INITIAL FIRE SAFETY INSPECTION REPORT

Garments Manufacture JINLITE Bangladesh Ltd

RSC ID: 24937

Date: 15/02/2024

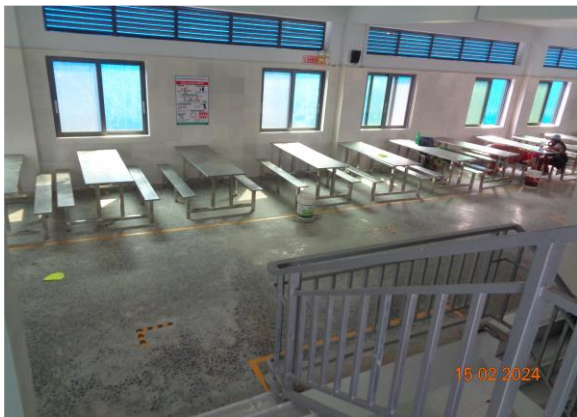
Sl No.	Category	Findings	Required Action	Remediation Time Frame
1	Fire Rated Construction	Rooms used for combustible storage are not separated by fire rated construction.	Separate the dedicated storage rooms by minimum 1-hr fire-rated construction. Provide 0.75 hr. fire rated door and seal all penetrations and openings by 1 hr. fire rated fire rated barrier construction.	Within 3 months

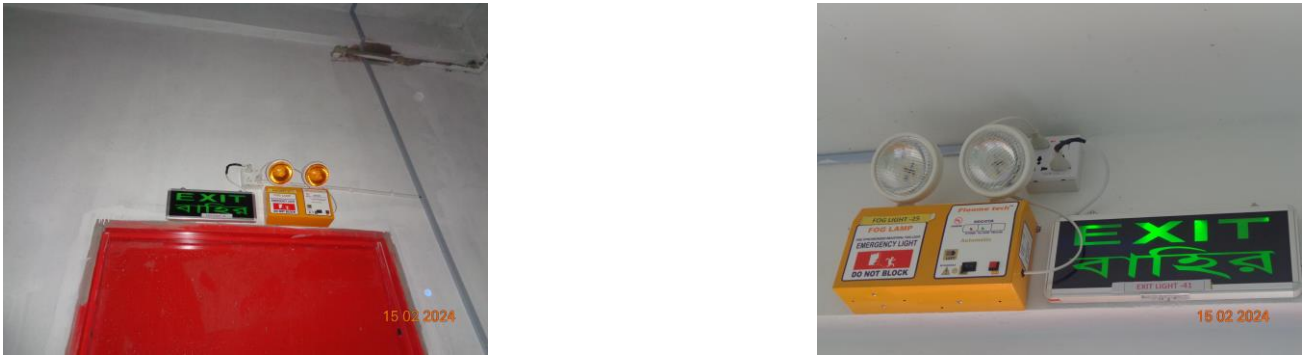
5	Means of egress	The width of the exit stair is less than 1.5 m (60 in.). Location: Canteen Building	In new and interim construction and constructed stairs post 24 November 2013, stairs shall have a minimum width of 1.5 m (60 in.) for all industrial occupancies and 2.0 m (79 in.) for all assembly occupancies. For assembly use areas provided for prayer halls, dining halls and like areas that are for integral use by the factory workers, the minimum width for the primary occupancy use of the building shall be permitted to be used.	Within 3 months
6	Means of egress	Handrails are not provided on both sides of exit stair. Location: Shed 1, 2 & Canteen Building	Provide handrails on both sides of the exit stair. New handrails shall have a minimum height of 865 mm (34 in.) and a maximum height of 965 mm (38 in.) as measured from the leading edge of the tread. Intermediate handrails shall be provided when the stair width exceeds 2.2 m (87 in.	Within 3 months
